South Coast Air Quality Management District

September 24, 2019

Draft Environmental Impact Report (Draft EIR) for the Proposed Interstate 15 (I-15) Logistics Center Project (SCH No.: 2018011008)

Figure 1: South Coast AQMD Staff's Screenshot of Proposed Project's Line-Volume Truck Emission Sources in AERMOD

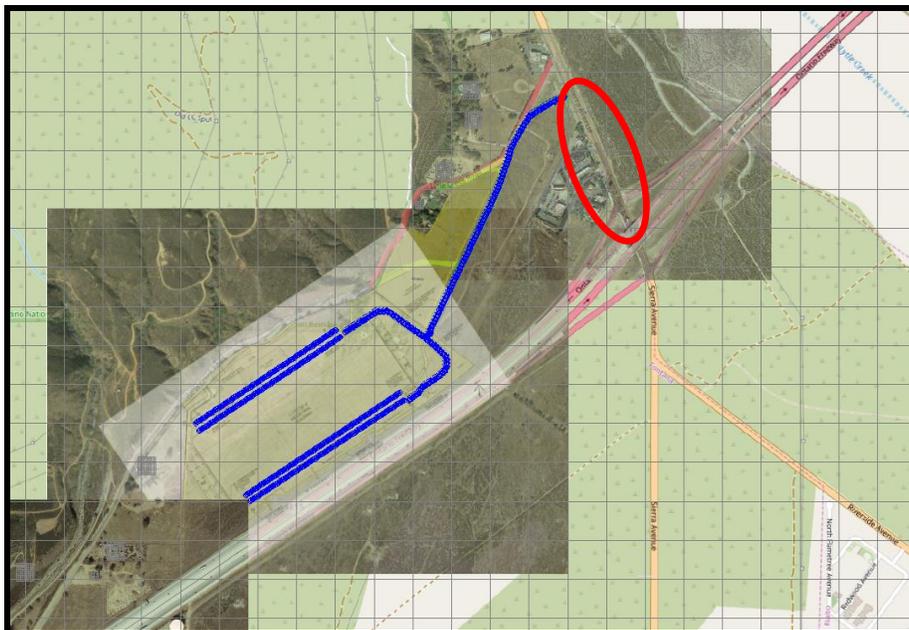
2. The Lead Agency used AERMOD to model the dispersion of the Proposed Project's emissions and perform a health risk assessment (HRA). In AERMOD, the Lead Agency modeled the dispersion of diesel particulate matter (DPM) emissions from heavy-duty trucks entering and exiting the Proposed Project, onsite travel, and trucks idling at the proposed dock doors. As illustrated in Figure 1, trucks entering and exiting the Proposed Project were modeled as a line-volume source from the Proposed Project's boundary to Sierra Avenue. However, it is recommended that mobile source emissions resulting from heavy-duty trucks visiting the Proposed Project be modeled to the nearest freeway on-/off-ramp. Therefore, South Coast AQMD staff recommends that the Lead Agency revise the air dispersion modeling to account for trucks traveling to and from the nearest freeway, in this case Interstate 15 (circled in red in Figure 1).
